Compliance Assessment Report for: NRW0037068

Permit number	BV7311IE	Operator name	Tata Steel (UK) Ltd.
----------------------	----------	----------------------	----------------------

Site name	Morfa Non Hazardous Landfill
Site address	Morfa Landfill, Port Talbot Steelworks, Port Talbot, SA32 2NG
Type of assessment	Site inspection & check sampling

Date of assessment	8 th October 2020
---------------------------	------------------------------

Figure 2: drawing showing location of primary² leachate monitoring points: L1; L6; L7 & L8. The Bio-cells also has additional dual purpose wells that function as leachate level monitoring points L2; L3; L4; L5; W10 & W11.

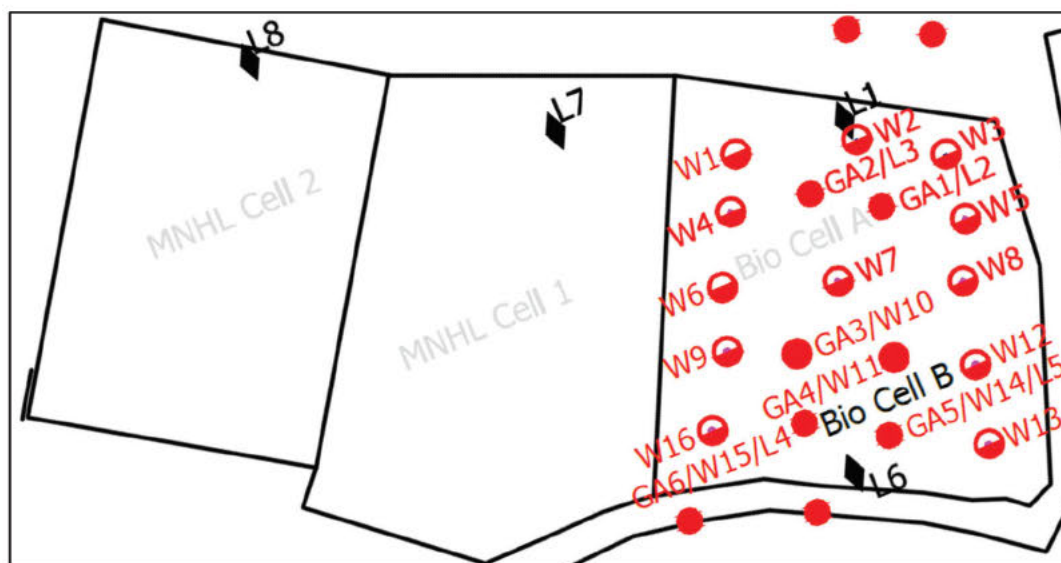
- Leachate level compliance has been problematic at the site over the last number of years, however this year the operator has succeeded in bringing all the cells within the landfill back into compliance³. This improvement is welcomed and is in part based on the operator's new leachate pumping system which was commissioned last year (see further details below).
- A check of the leachate levels in a random sample of the wells at the landfill was conducted by JD in my presence. Leachate levels were below the permit's compliance limits in all the monitoring wells that were dipped.

Figure 6. Working Plan drawing of site drainage

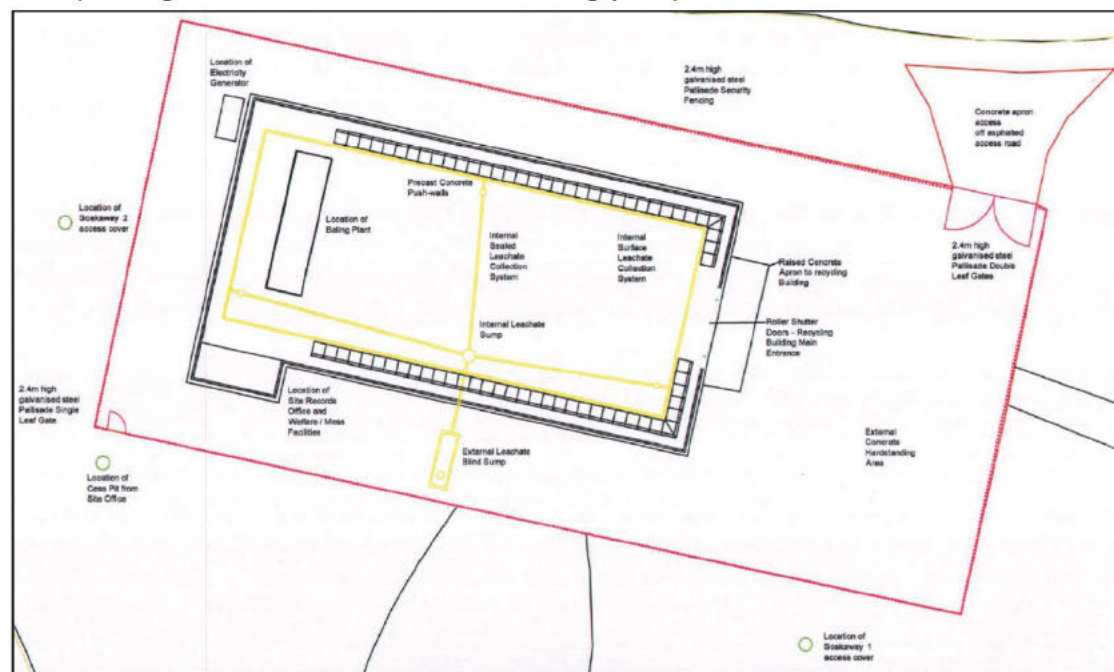
- Clean water from the yard and roofed areas is meant to be discharged into stone drains situated outside the site. It appears that water should also drain to a third French drain near the access gate. The drainage plan should be updated to reflect this (see figure 6 - taken from the working plan).

- Note: this suspected third drain requires some maintenance as water is not draining freely from the yard. It should further be noted that the daily inspection records indicate that no issues with the surface water drainage system was identified during the daily inspection. This is not likely and staff should be reminded of the requirement to keep accurate records.
